BULLETIN NO.
92-018

Trunk Unit CD Changer Magazine Won't Eject

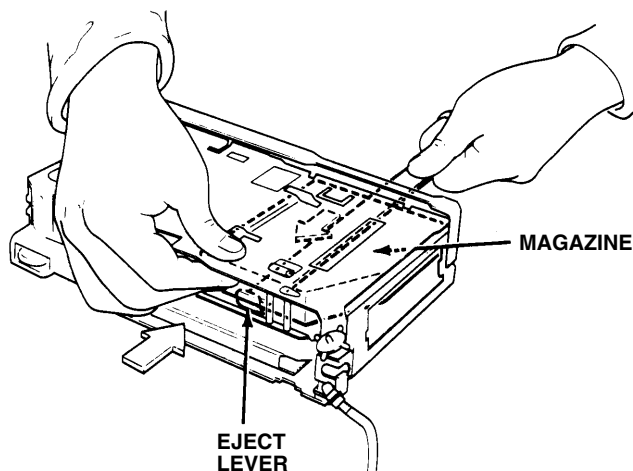
The CD changer magazine will not eject from the changer.

Replace the magazine in the changer, and any other *Acura* magazines the customers may have, with the improved magazine. See PARTS INFORMATION.

NOTE: Do not replace the CD changer for this problem. The improved magazine(s) will prevent future jamming.

1. Remove the CD changer from the car.
2. Remove the side covers and the top case.
3. Slide a slim jim or a stainless steel ruler between the lower side of the CD magazine and the changer.
4. Push the eject lever toward the back of the unit while pushing the magazine out of the front opening.

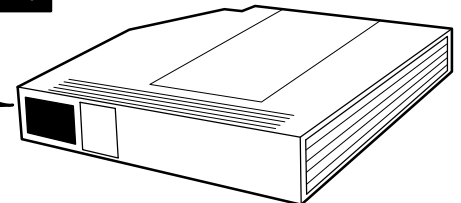
Improved changer magazines can be identified by this label.

5. Reassemble the CD changer.
6. Reinstall the changer in the car.
7. Replace the changer magazine with the new part.
